## **ARC Stadium Lighting Upgrade**

LRCCD BID NO. 20011

ADDENDUM 3: March 2, 2020

American River College Stadium Lighting Replacement DSA File No. 34-C3; DSA Application No. 02-117381

TITLE SHEET, GENERAL **NOTES AND PROJECT** INFORMATION

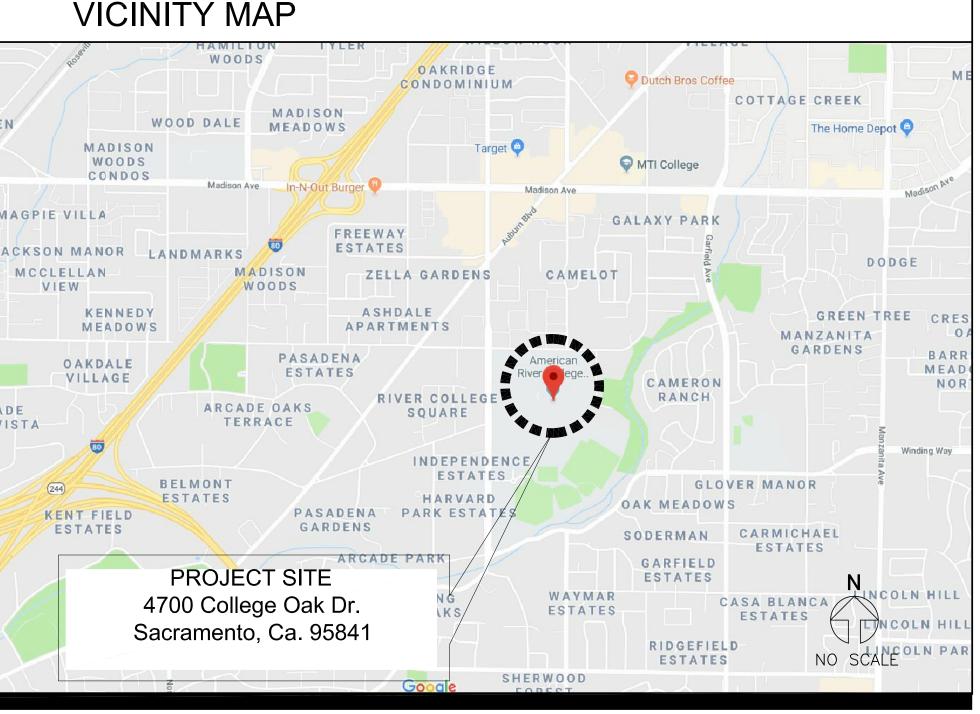
- 1. A0.0 TITLE SHEET, GENERAL NOTES AND PROJECT INFORMATION
  - A. Update Project Summary and Scope of Work to remove existing light pole work at platforms.
- 2. A0.1 OVERALL SITE PLAN
  - A. Update Project Scope of Work to remove existing light pole work at platforms.
  - B. Update notes on photo of existing platform.
  - C. Update notes on photo of existing light poles.

OVERALL SITE PLAN

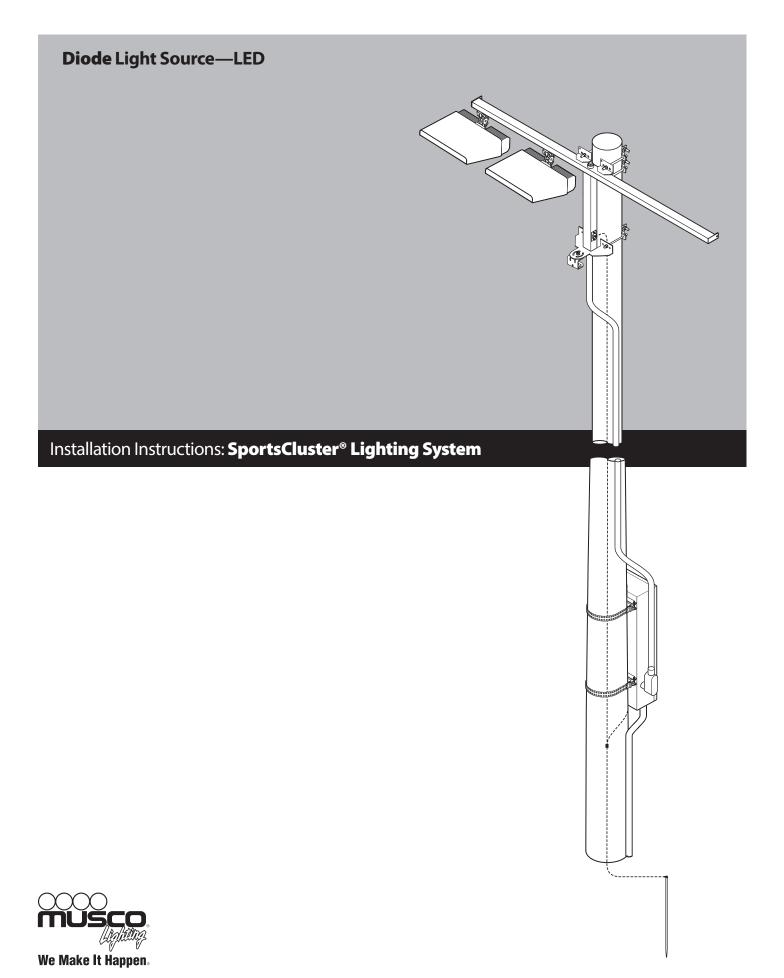
- 8. Are the existing landings attached to the light assembly. If so, how are they to be removed and attached to the new assembly?
  - A. Landings are to be removed completely from the pole assembly. See updated Sheet A0.0 and A0.1.
